UNITED STATES PATENT AND TRADEMARK OFFICE

Office Action Summary	Application No. 10/805,787	Applicant(s) CHILDS, MONTGOMERY W.	
	Examiner Mark A. Deuble	Art Unit 3651

DETAILED ACTION

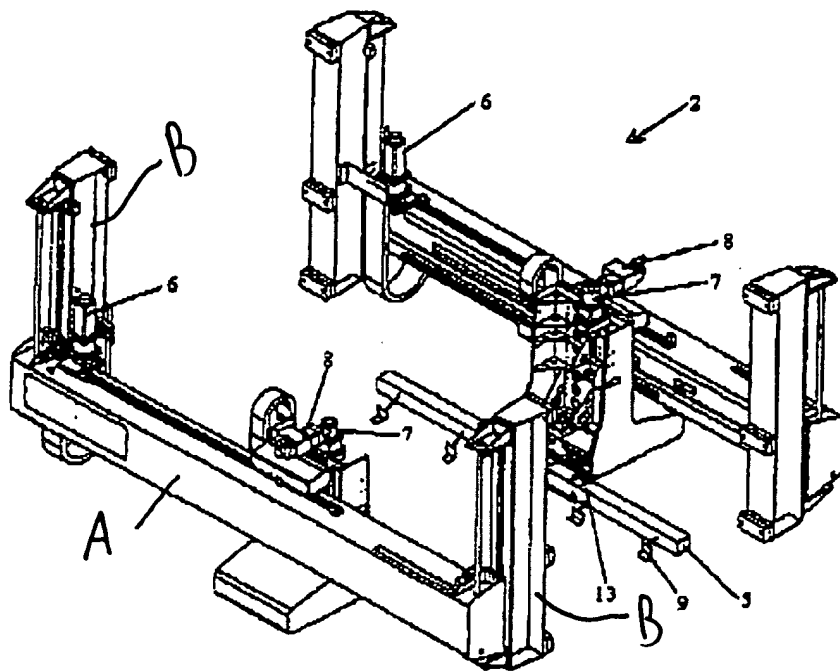
Childe et al. shows a transfer system for transferring workpieces between successive die stations in a stamping press 1 having left, right, front, and back sides. The transfer system includes a horizontal support beam A adapted for placement adjacent one of the sides of the press, a supporting structure B which supports the beam, and a mounting head 13 mounted on the support beam for horizontal movement along the support beam (see Fig. 4 reproduced below).

Each mounting head includes a coupling 18 at the distal end thereof which mounts an elongate bar 5 with a series of workpiece holders 9 thereon to the mounting head. The mounting head includes a vertical transport mechanism 8 which moves the mounting head and the coupling vertically. A longitudinal transport drive 6 is coupled to the mounting head to move the mounting head in a left-right direction relative to the press. Thus Childs et al. shows all the structure required by claim 11.
